585-310-406
Issue 1.0
March, 1995

Intuity CONVERSANT VIS Version 5.0 Change Description

Figure 1. Switch Settings for T1 (AYC11) Circuit Cards, T1-0 through T1-4 in a System with Token Ring Circuit Card

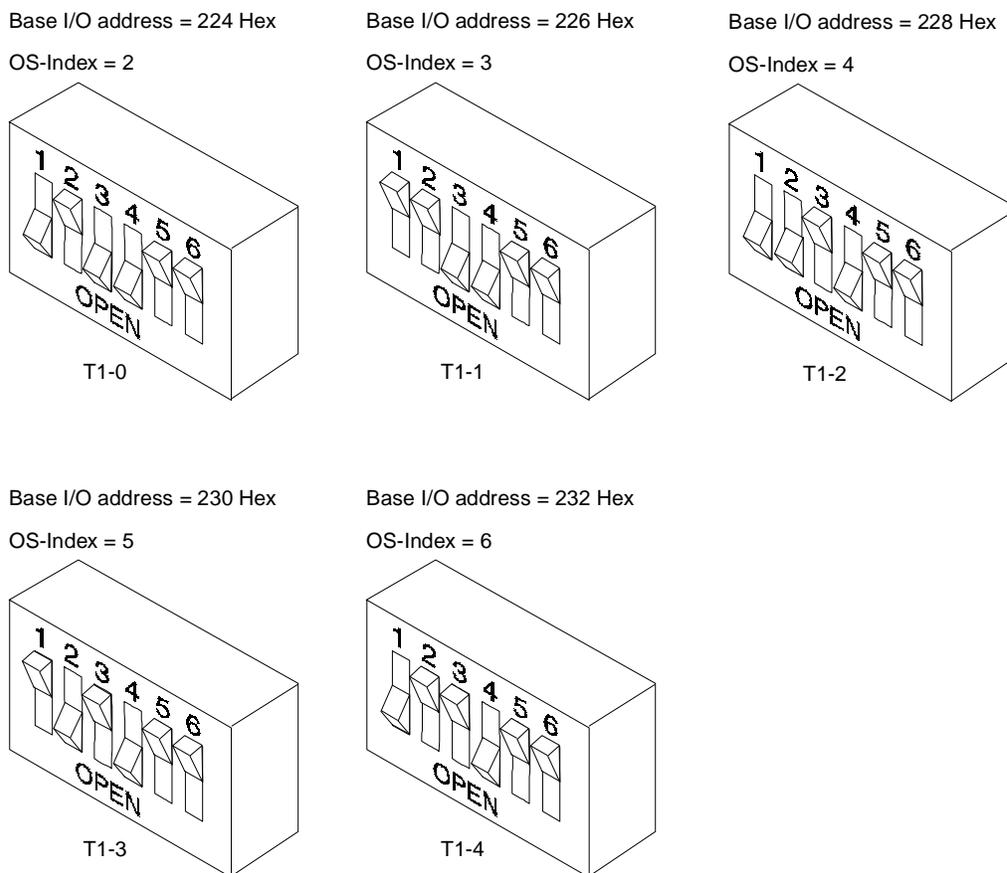
- *Problem description:* In systems equipped with T1 and Token Ring card, a conflict exists in the I/O address between T1-0 and T1-1, and the Token Ring card.

Work-around: The base I/O address switch settings of all T1 cards must be reset when a Token Card card is present in the system.

Figure 1 illustrates the proper DIP switch settings for all T1 cards residing in a V5.0 system that is also equipped with a Token Ring card.
